TOWN OF PLYMOUTH

ADDENDUM 4

TO: Potential Bidders
FROM: Pamela D. Hagler, Procurement Officer
DATE: August 9, 2016
RE: 21611, Joseph Simes House Renovations Phase 2

Excavation Guidelines for Underground Propane Tanks

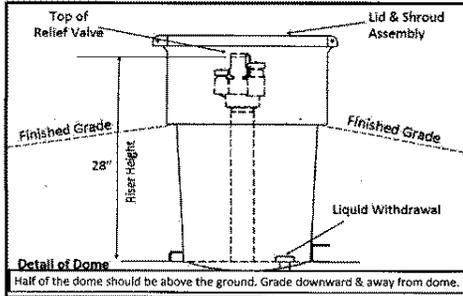
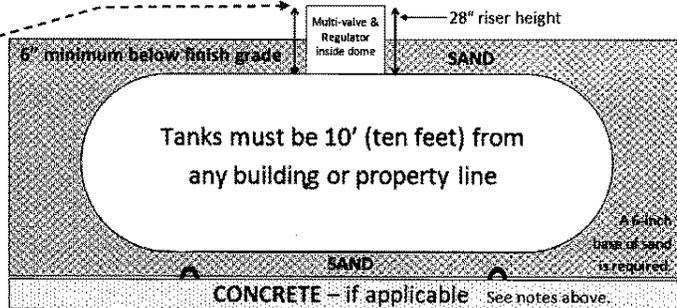
- The due date for general bids has been postponed from Thursday, August 11, 2016, to **11:00 a.m., Wednesday, August 17, 2016.**
- **Page 74 , Supplemental General Conditions, Section 3.4-Builders' Risk Property Coverage:**
The Replacement Cost Value of the building is \$4,500,000, therefore, that is the amount of coverage for builders' risk insurance required for this project.
- **Response to RFI dated 8/5/16 by question number:**
 1. There is no plan showing the existing footings under the South and west porches. The piers can be observed on-site, but most of the footings have not been exposed.
 2. As shown on sheet L3, bituminous walkways will run through parts of the reinforced turf pavement area.
 3. Depth of Engineered Gravel Levelling Bed: 12" (AASHTO #M43 #6). Engineered Drainage Layer not required (omit)
 4. Propane pit - See note on sheet L3 and detail below
